June 10, 2014

Re: WDSC Ballot I for Special Design Provisions for Wind & Seismic (SDPWS) (04/2014) Finding of Non-Persuasive on Ballot I-1 Lawless Negative

Figure 1: E72 Test Setup – Front view

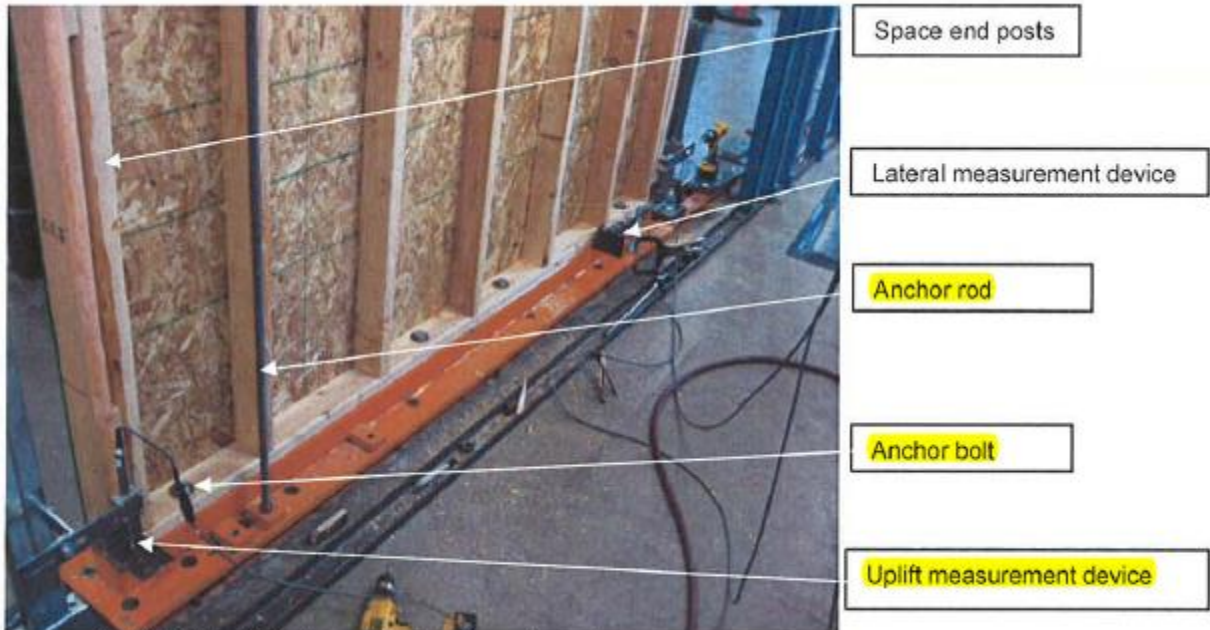
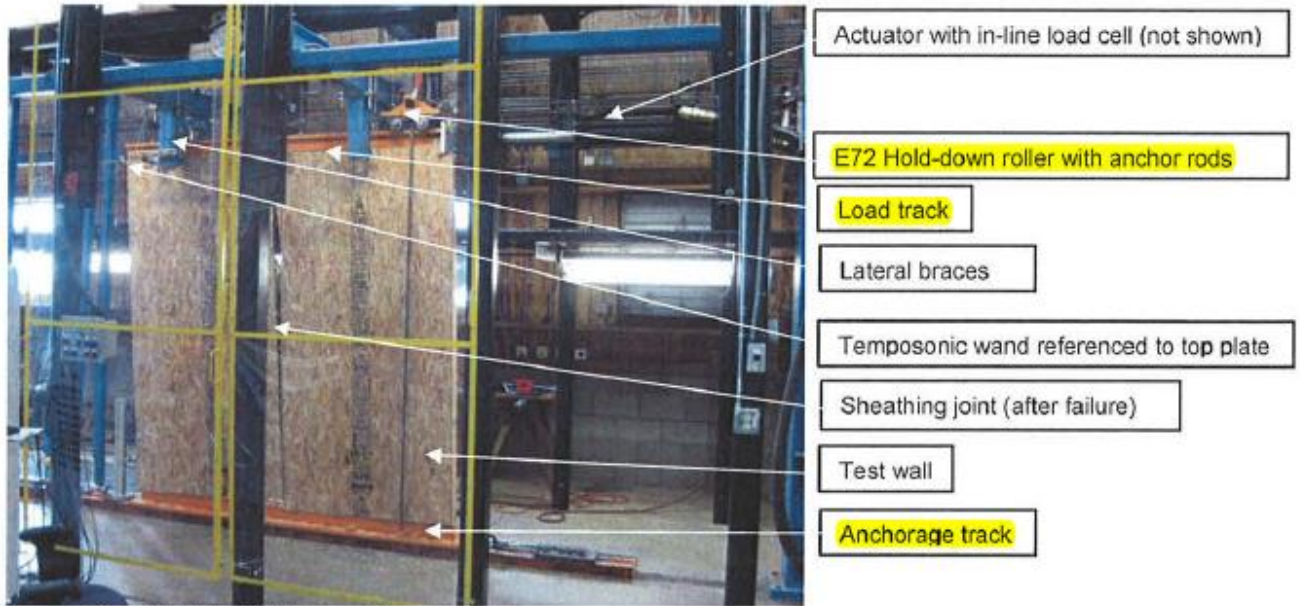
- d. We believe that E72, which applies a vertical load through a threaded rod hold down, and a lateral load applying distribution beam (e.g., wood, steel, etc.), of which the applied vertical load and added stiffness to the top plates is of an unknown amount, does not reflect testing that can easily be used to establish allowable design values in actual building constructions. The following photos are good demonstrations of the differences between E72 and actual building construction ([Attachment 3](#) – [pages 8 and 9].....Weyerhaeuser Report 2379A - E72 Testing of WSP):

Additionally, as described above, the NUSC values are not correlated to performance in actual building construction given the effect of the E72 test apparatus forcing a rectangle into a parallelogram (which is obvious when looking at the test apparatus pictured above). Non-correlation suggests the E72 test boundary condition effects do not change the load path through the wall in a way that is different than in actual building construction.
